Transmittal

Re: Petrenko – 33 Woodland Road, Bedford, NY

Below please find the following responses from the Staff report dated August 8, 2022 and the Town Engineer Consultant memo dated September 9, 2022.

2 MINI CHANNEL DRAIN
SCALE = N.T.S.

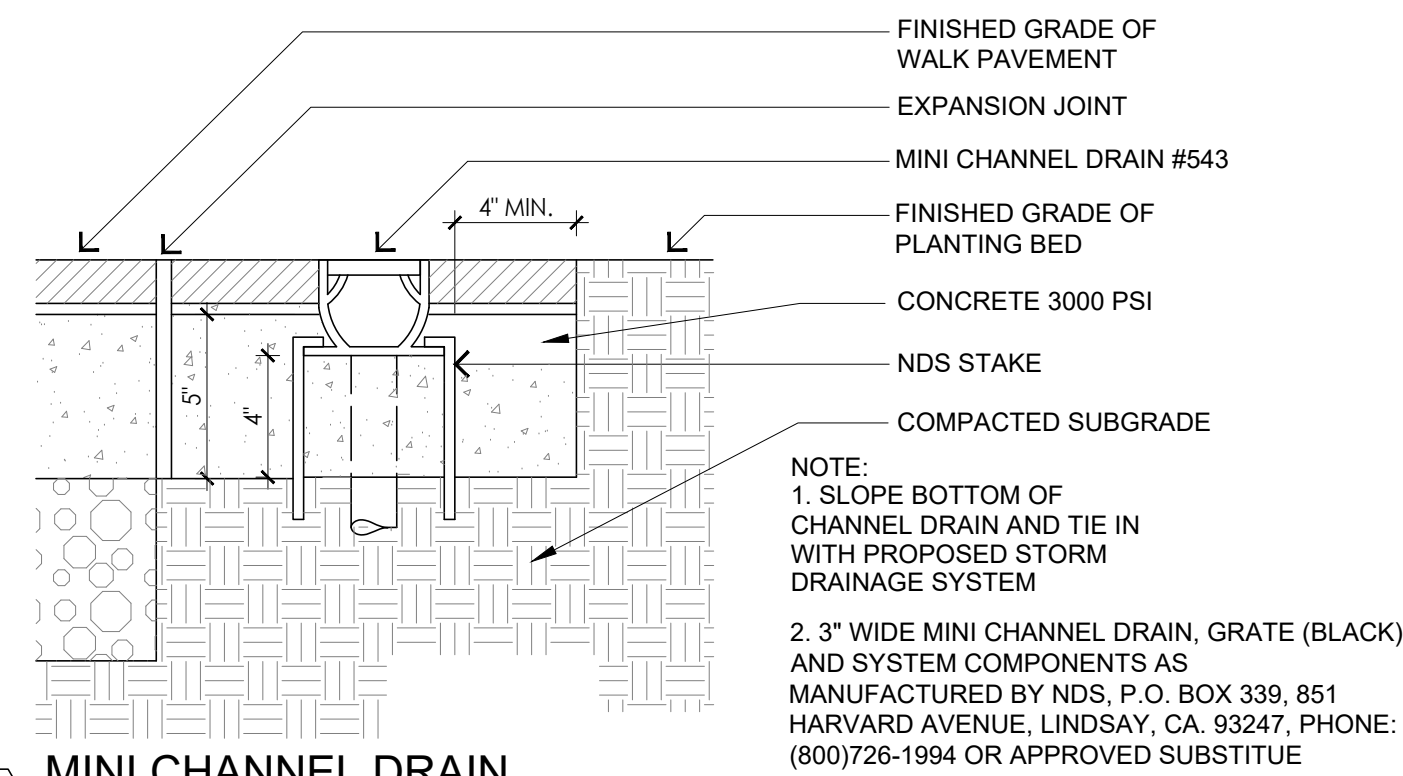
Item #7 – The Pool area and patio areas have been sized to handle the 25 year storm event required for the design storm. As an added benefit the pool cover pump would not typically be used during a storm so the infiltrators would have time to percolate and provide additional storage from what is designed. A 3" NDS mini Channel drain is proposed to catch and divert the stormwater to the infiltration units. This is a common drain used often as it has a high volume flow rate. At a sensible slope of .25% it can handle 31.4 gallons per minute per foot. 527 gallons (70 cu. Ft.) for a 17 l.f. drain. That equals 1.5" of rain per minute over the largest patio area of 536 s.f. Well beyond what is required.

5 SPLIT RAIL FENCE WITH 1" WIRE MESH
SCALE = N.T.S.

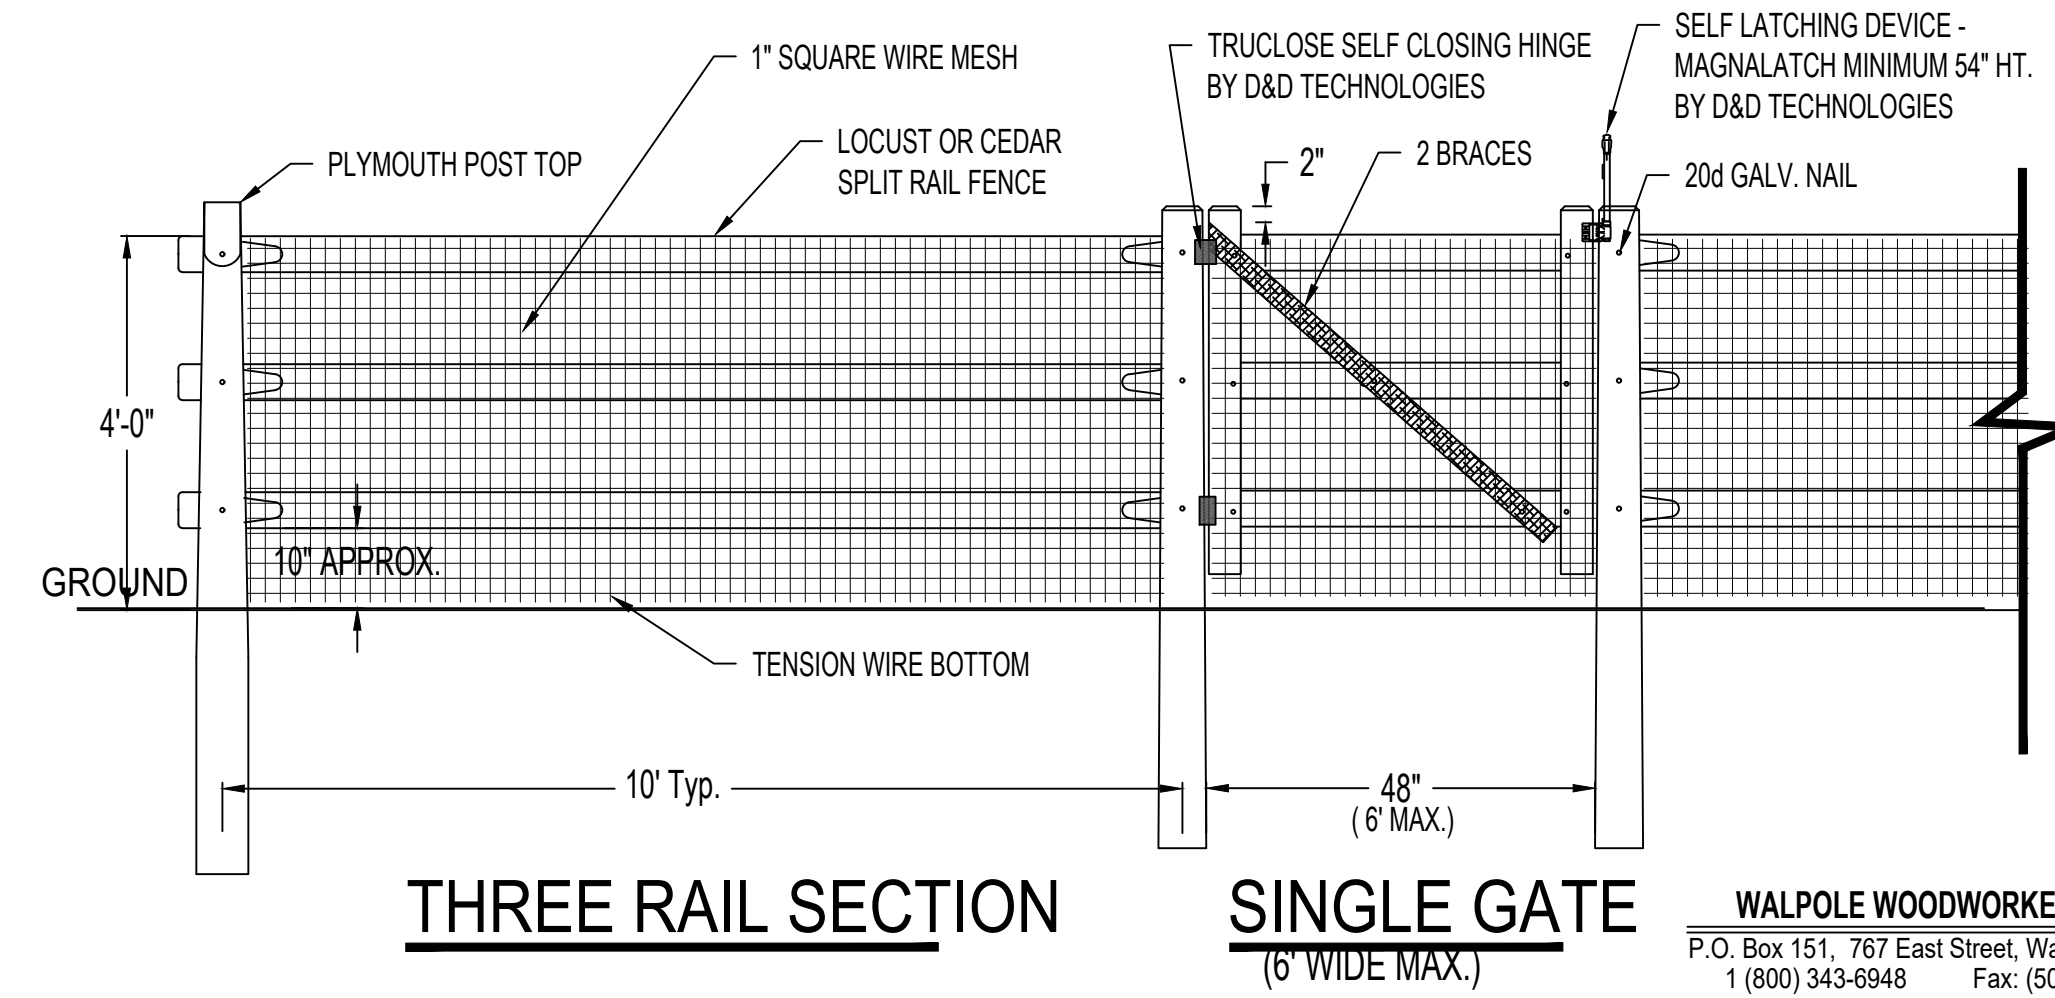
Item #4 – The fence detail can be found on sheet L-3.0 (detail 5) along with specification of self-closing hinge and latch devices.

drawing number: **L-4.0**

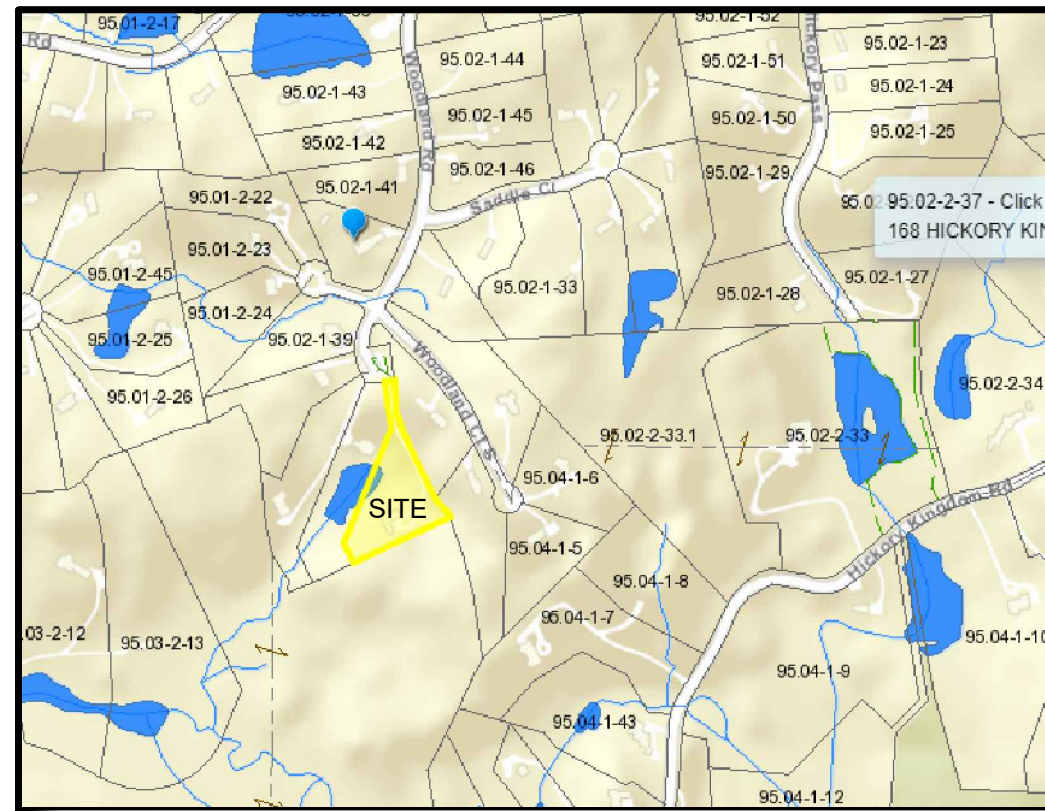
Item #3 – The mitigation plan has been modified with additional planting along the pond edge that removes portion of existing lawn and provides an additional filtration of silt, and unwanted chemicals such as nitrates and phosphorus. The red maple tree adjacent to the pond has burls along the trunk that may reduce the health of the tree slightly but are otherwise not harmful to neighboring trees or vegetation. The owner is fond of the fall color and would like to keep that tree.

SHEET: 2 of 3

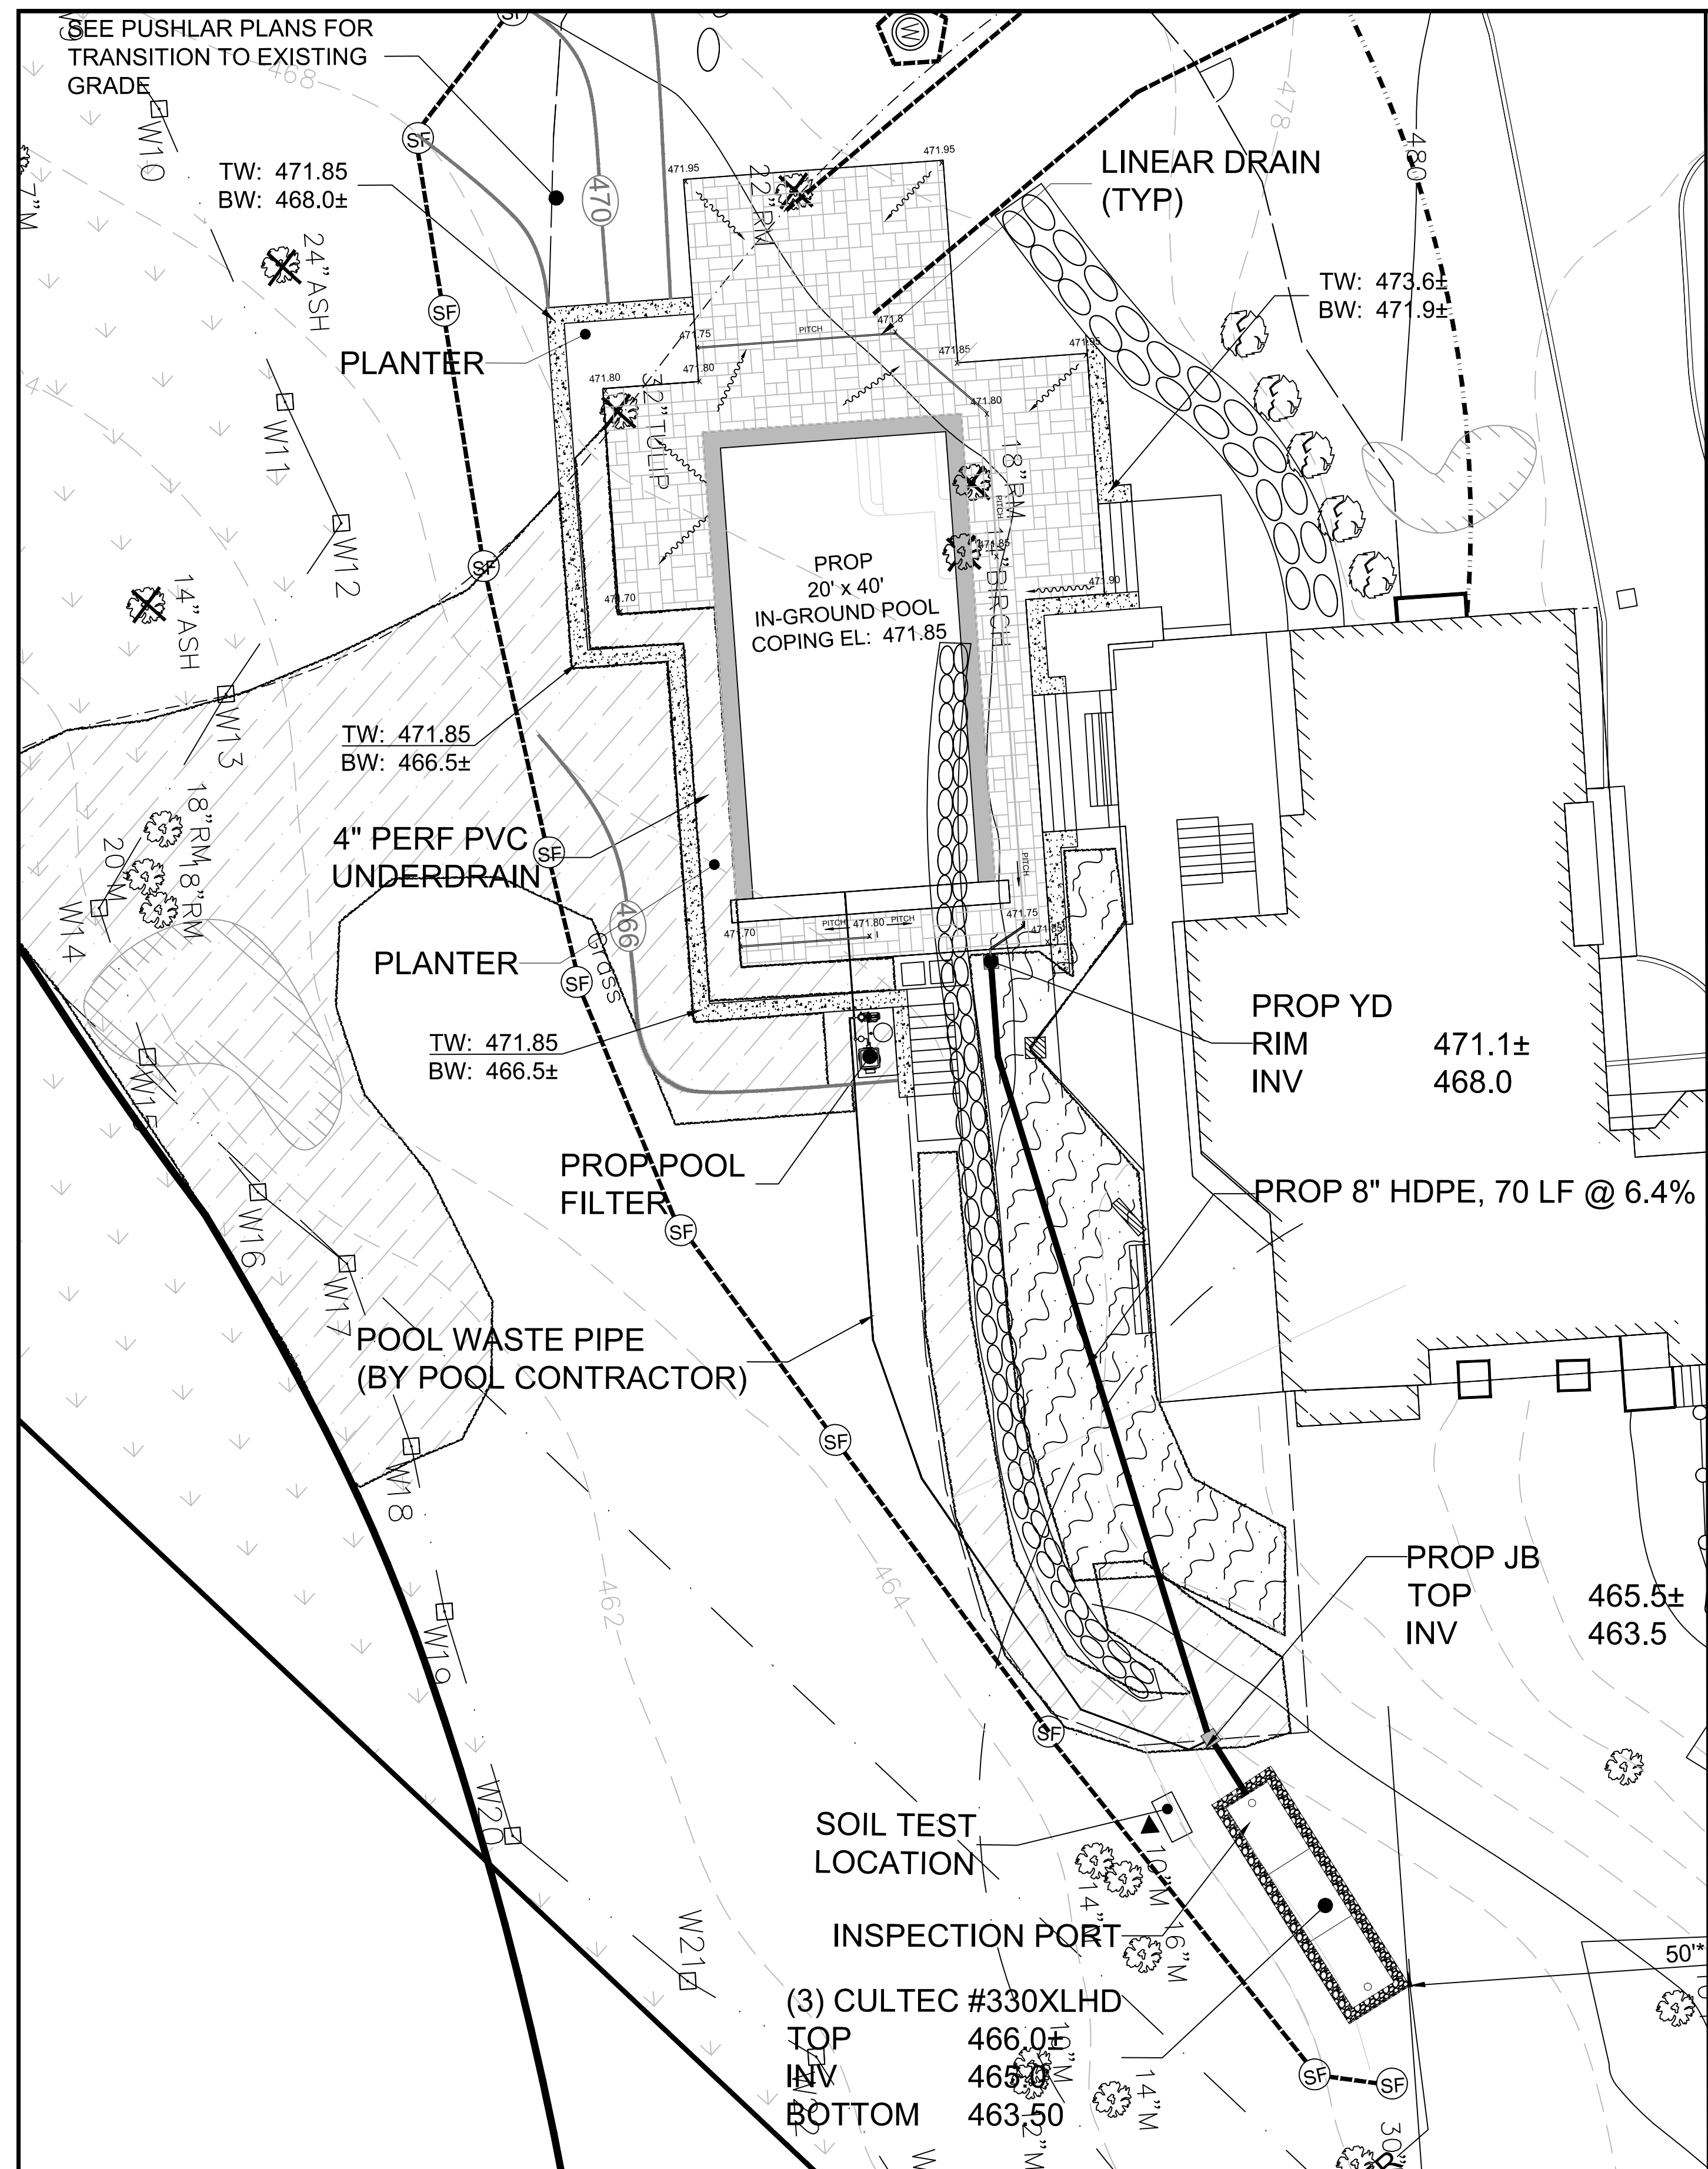
Item #9 – The proposed infiltrators are over 50' from the existing and reserve septic fields as noted on the engineering plan sheet 2 of 3. The well is 155' from the proposed infiltration units.
